ADDENDUM NO. 02
TO THE CONSTRUCTION DOCUMENTS BID PACKAGE

Client: Arrowhead Regional Medical Center
Project: Oncology-Ambulatory Clinic
SHA Project No.: 18242.100
Date: September 12, 2019

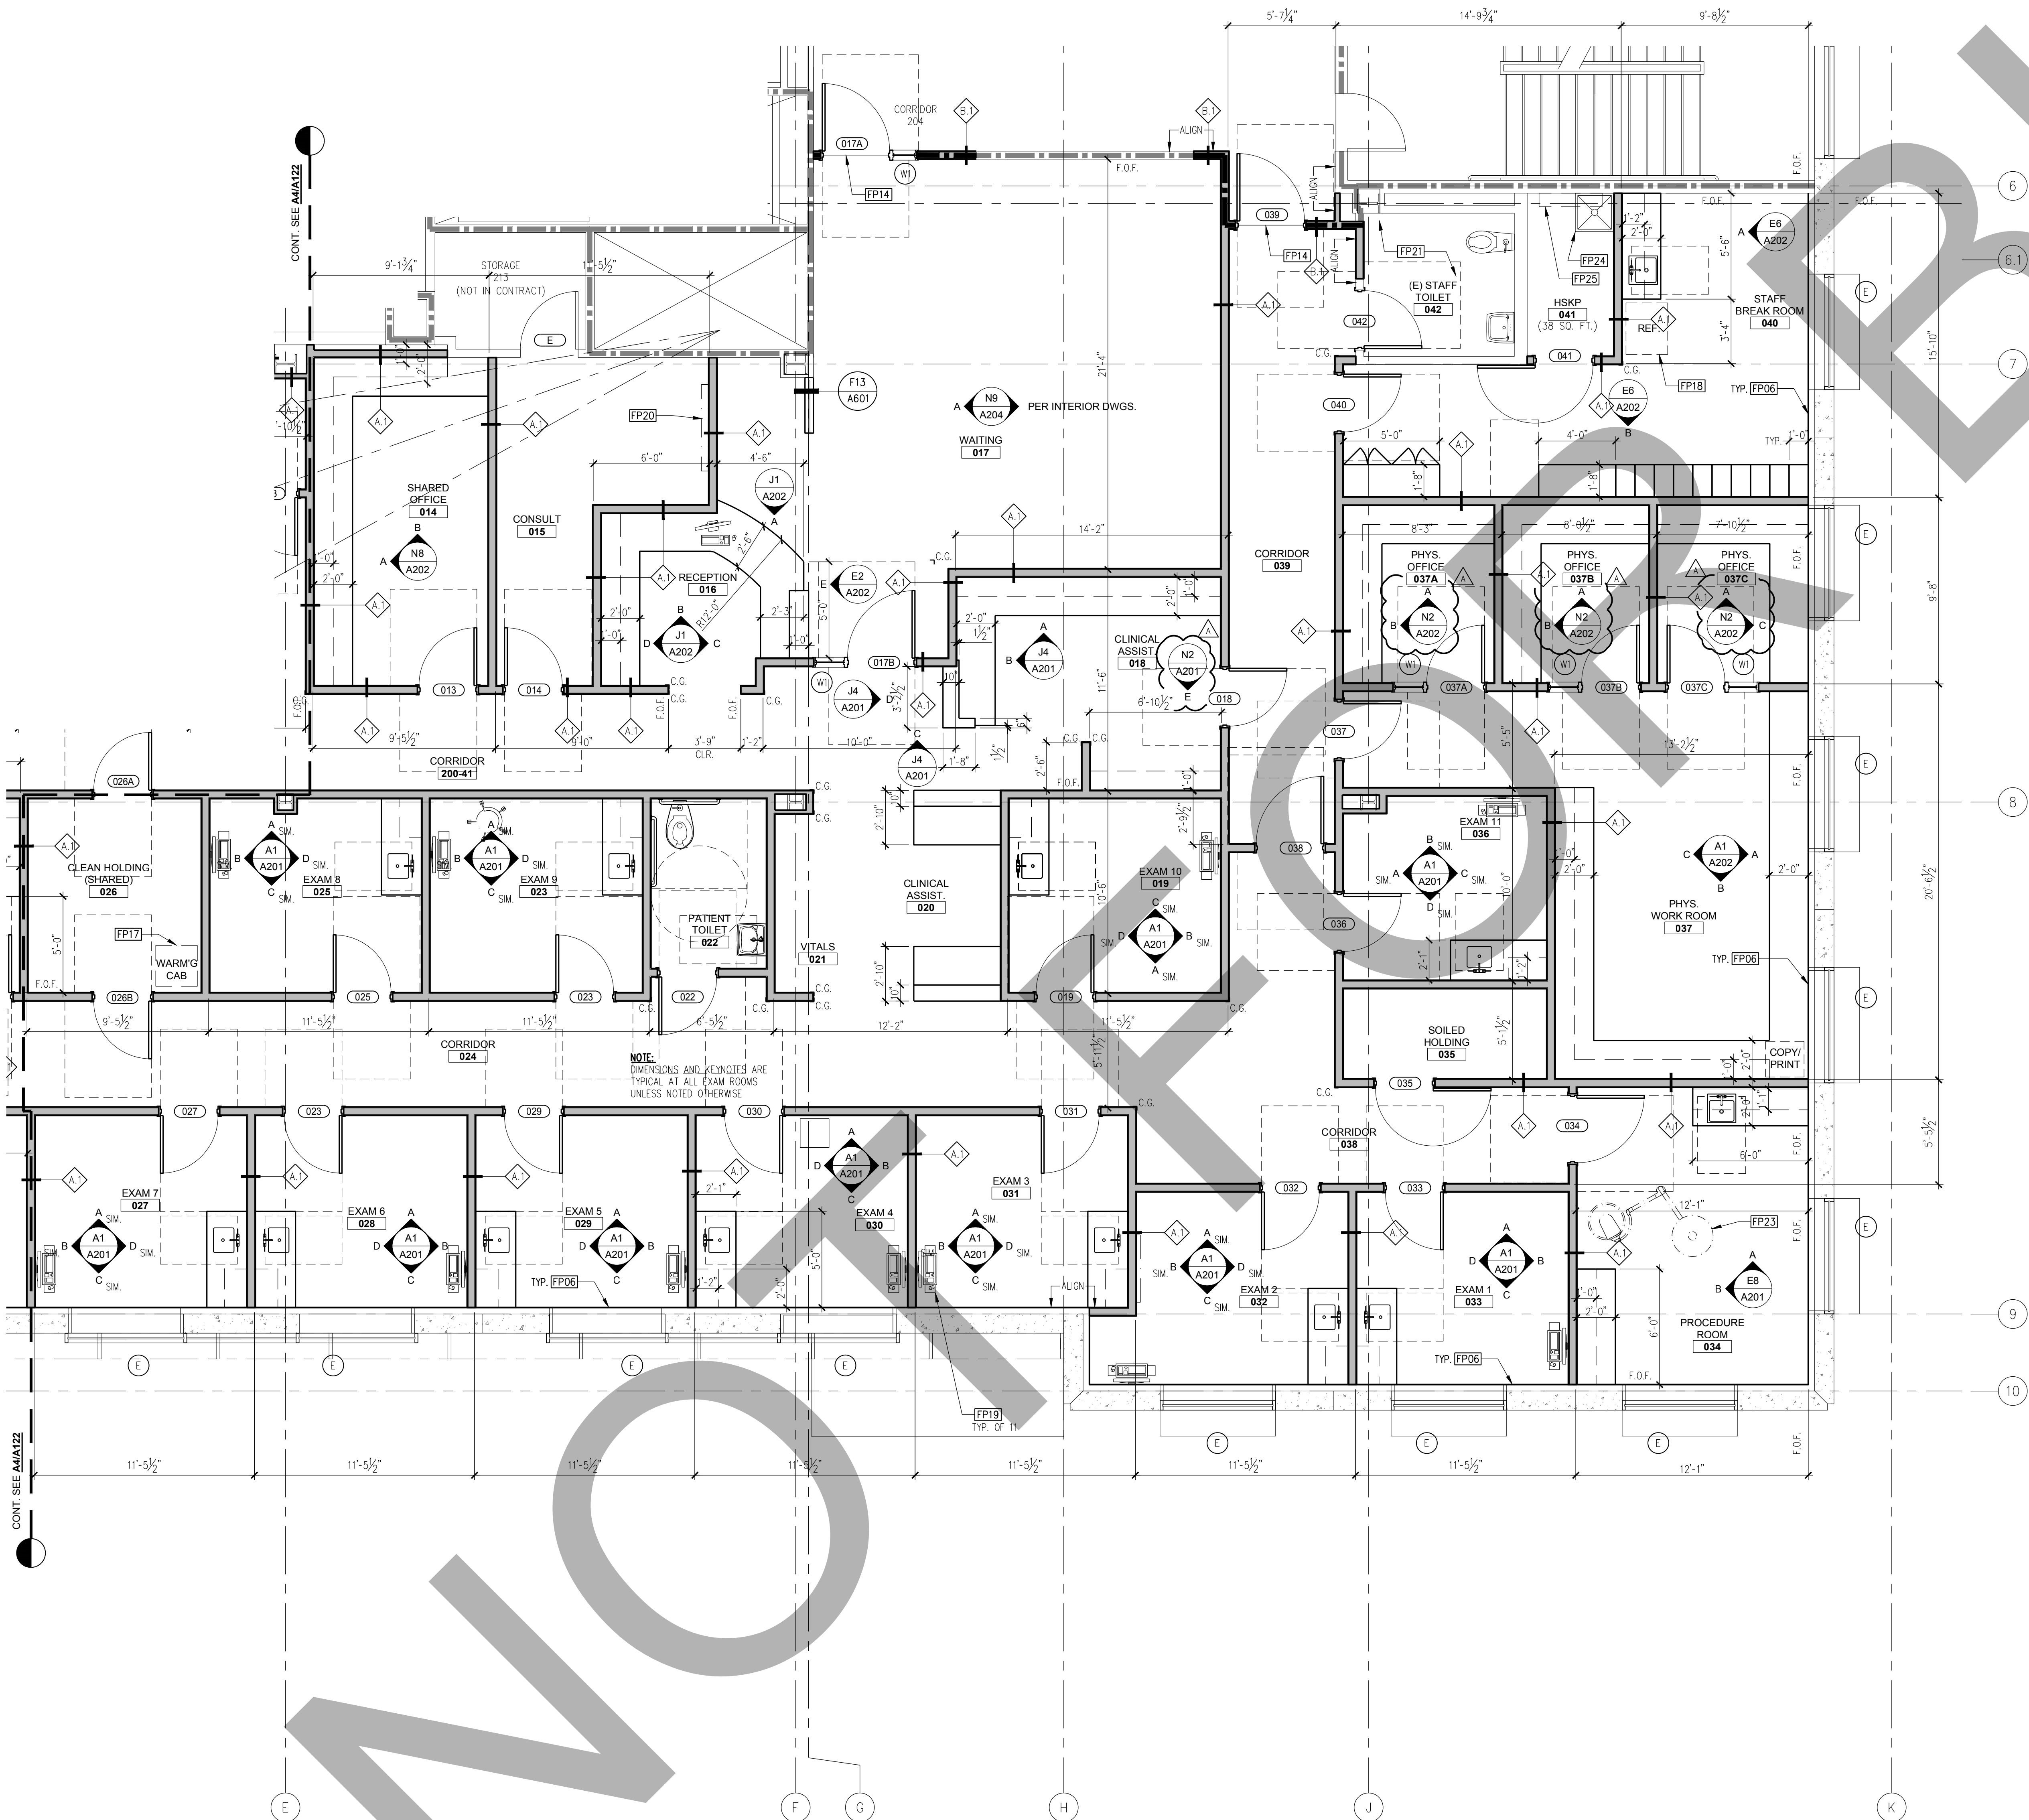
A122 Keynote FP06 revised to indicate new gypsum board at existing framing.

General Note regarding Owner Furnished Items added to General Notes.

007.1	Keynote DM04 on sheet A111 Demolition Plan calls to "Demolish Existing Gypsum Board On One Side Only, Protect Framing In Place" along the West, South & East perimeter walls, but keynote FP06 on sheet A122 Floor Plan - Area A calls for "Existing Gypsum Board Furring to Remain, Protect in Place. Please advise if existing gypsum board along the perimeter wall is to remain, or to be demolished and replaced with new framing and drywall.	Existing gypsum board along all perimeter walls is to be demolished. FP06 on sheets A122 and A123 has been revised to indicated existing framing with new 5/8" gypsum wall board.

- FP05 PLASTIC LAMINATE ACCESSIBLE SINK APRON WITH SOLID SURFACE COUNTERTOP
- FP06 PROVIDE 5/8" TYPE 'X' GYPSUM WALL BOARD AT EXISTING FRAMING
- FP07 PLASTIC LAMINATE RECEPTION COUNTER WITH SOLID SURFACE COUNTERTOP

FLOOR PLAN - AREA 'B'

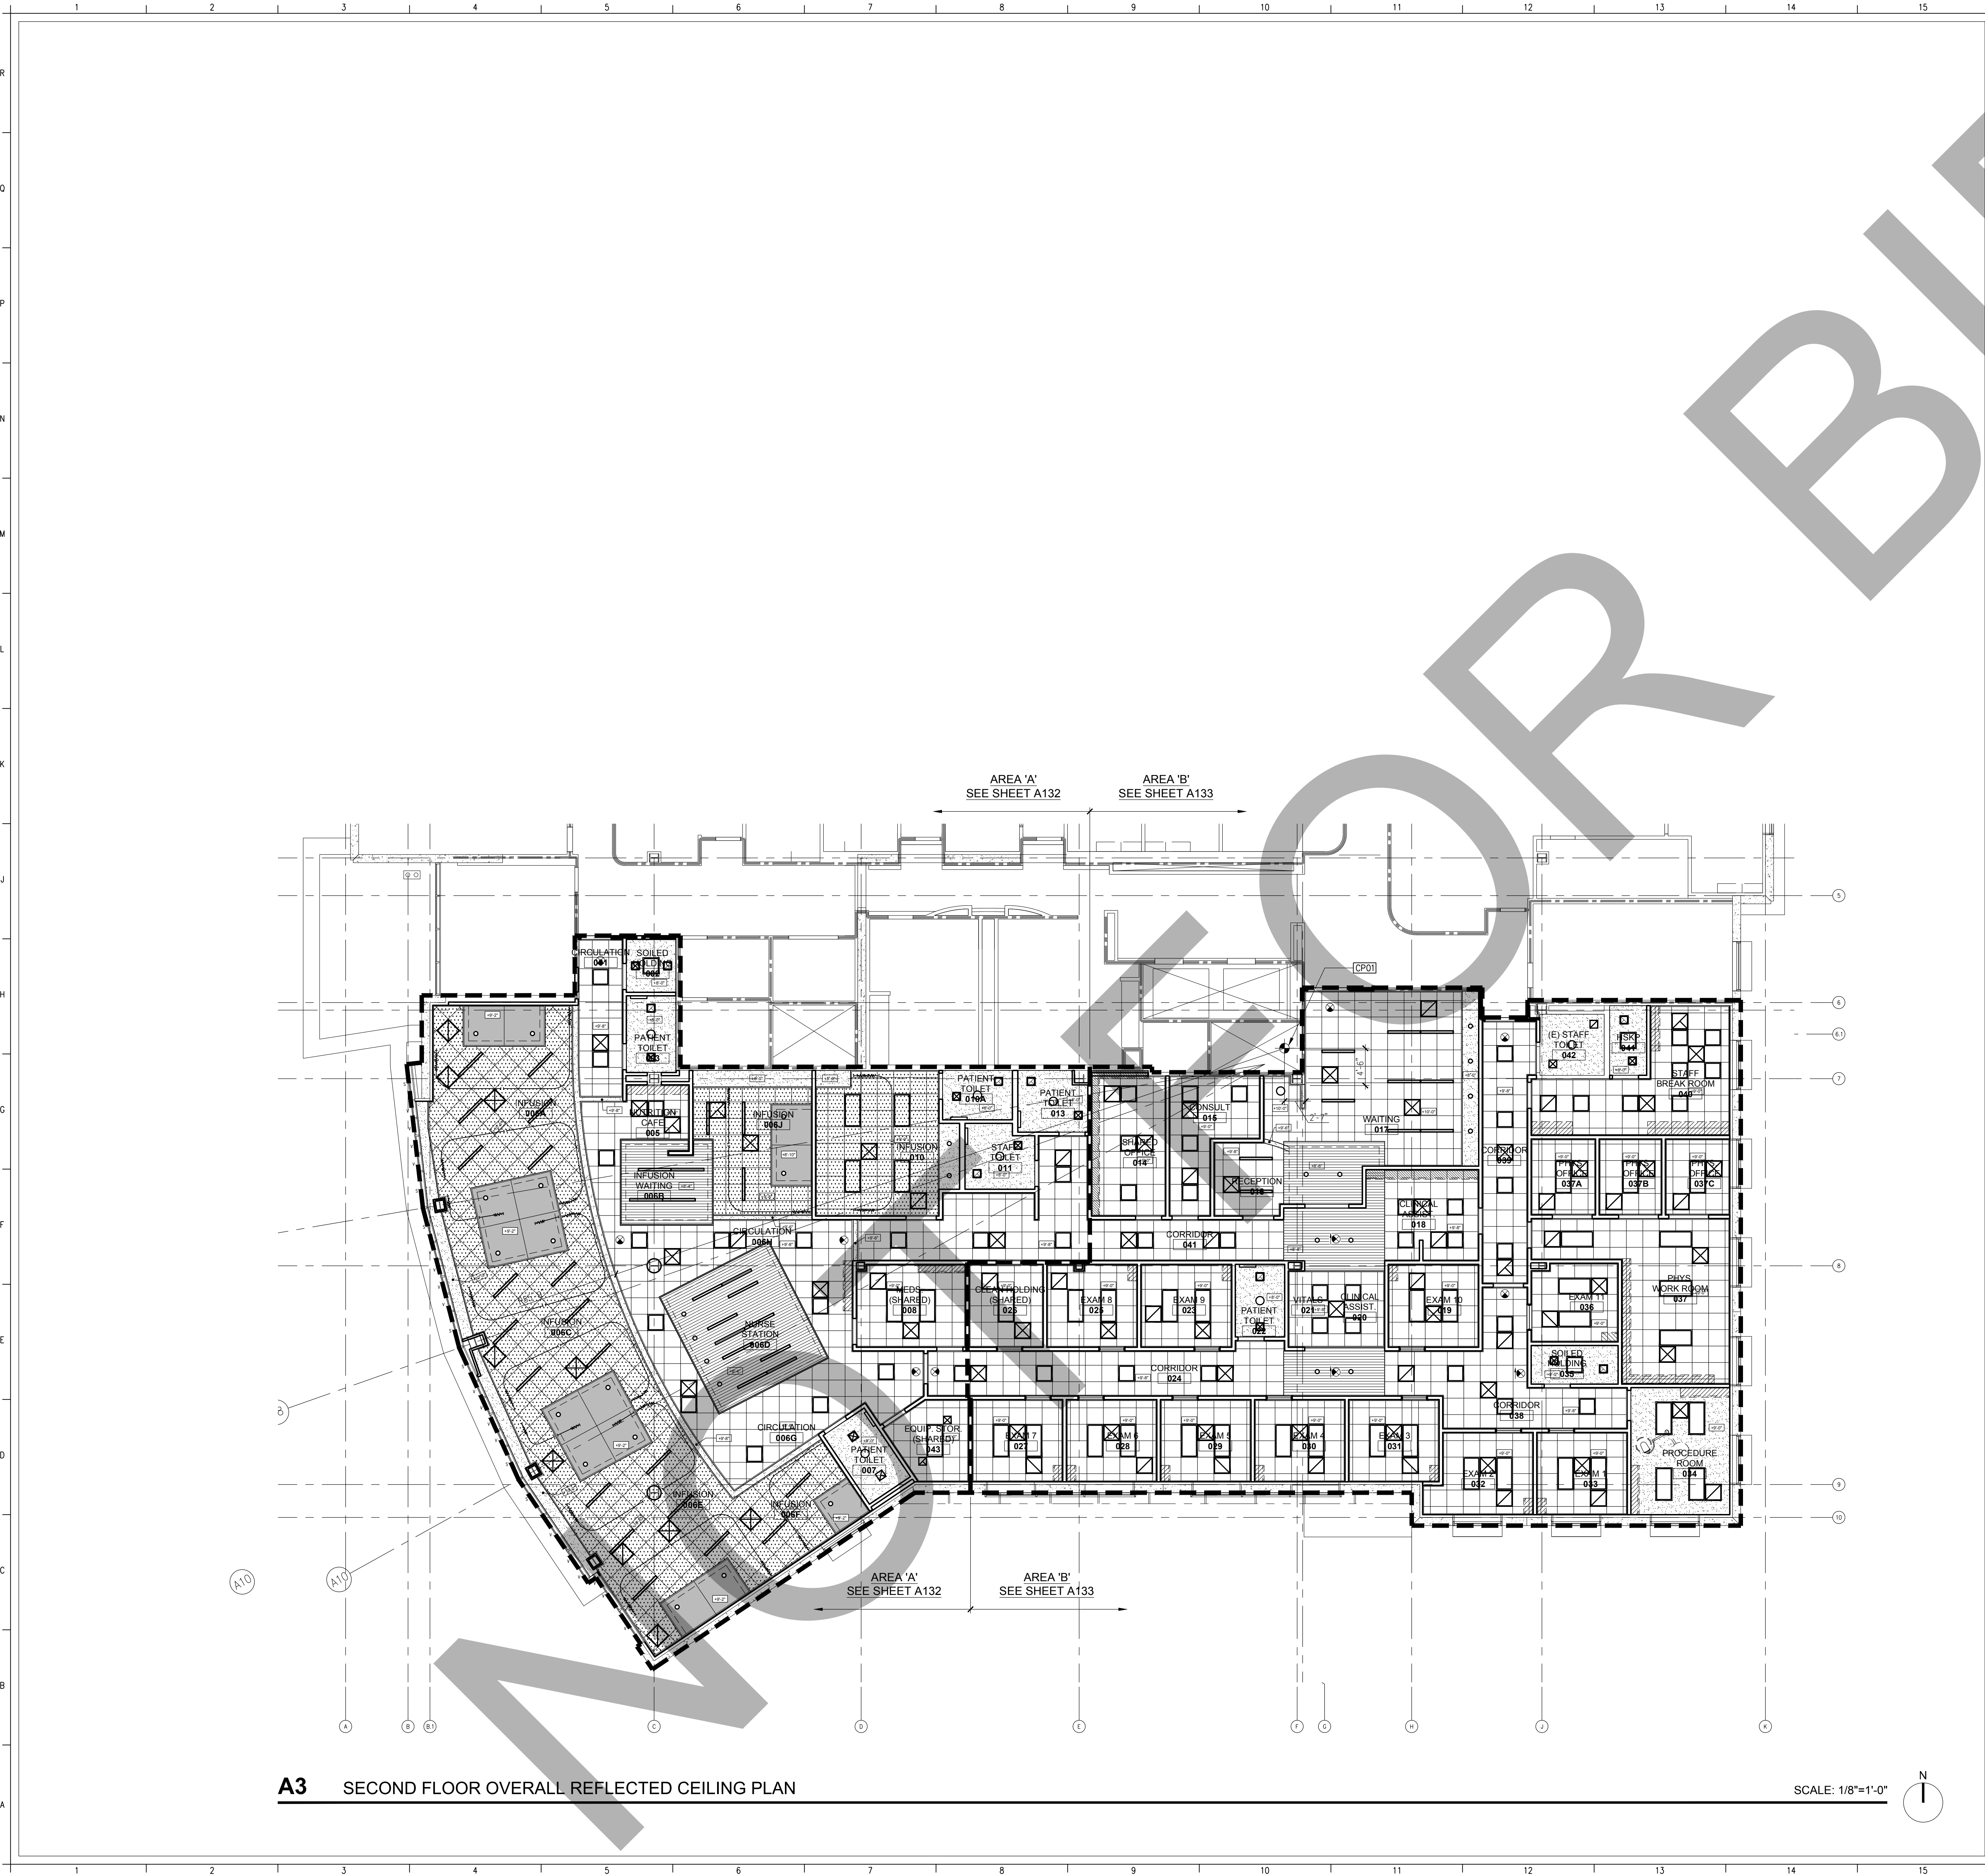
- A123** Keynote FP06 revised to indicate new gypsum board at existing framing.
- A131** General Note added to sheet regarding patching back of existing ceilings in corridor.
General Note regarding Owner Furnished Items added to General Notes.

N2 CLINICAL ASSISTANT 018 SCALE: 3/8"=1'-0"

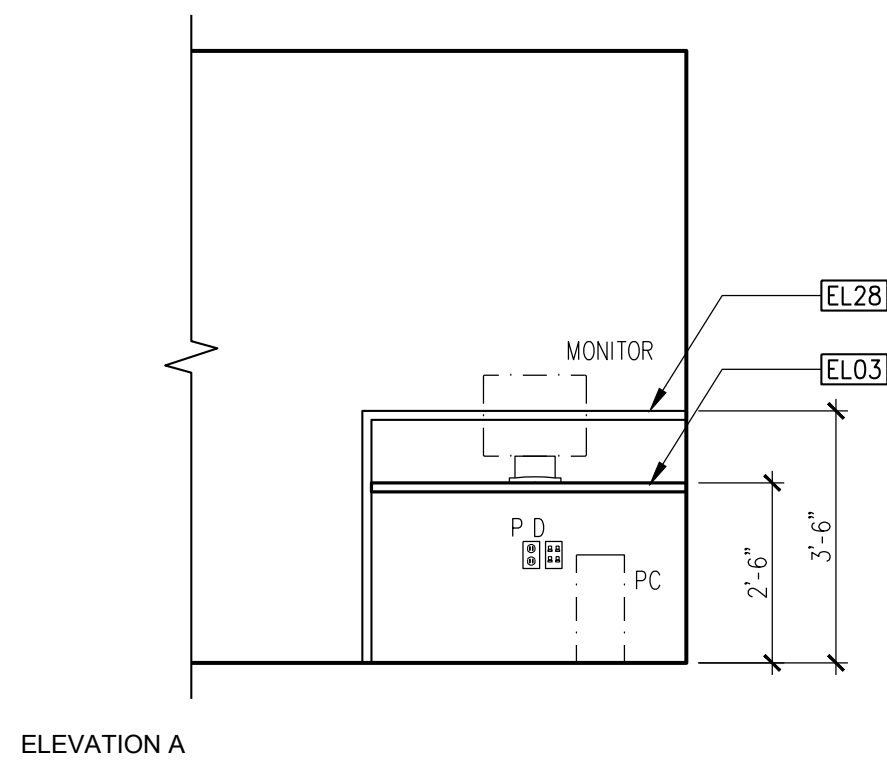
- A201** Clinical Assistant 018 Interior Elevation E added to sheet at N2/-.
Cabinet locks added to various elevations and Keynote EL30 added to Keynotes.
General Note prohibiting cabinet locks at accessible sink aprons added to General Notes.
Detail callout revised to reference correct detail.

- REFER TO EQUIPMENT SCHEDULE FOR MORE INFORMATION ON EQUIPMENT SHOWN ON THIS PLAN AND IN THE EQUIPMENT LIST.
- REFER TO INTERIOR DESIGN DRAWINGS FOR ALL NURSE STATION AND RECEPTION COUNTER CASEWORK DETAILS.
- CABINET LOCKS SHALL NOT BE PROVIDED ON ACCESSIBLE SINK APRONS.
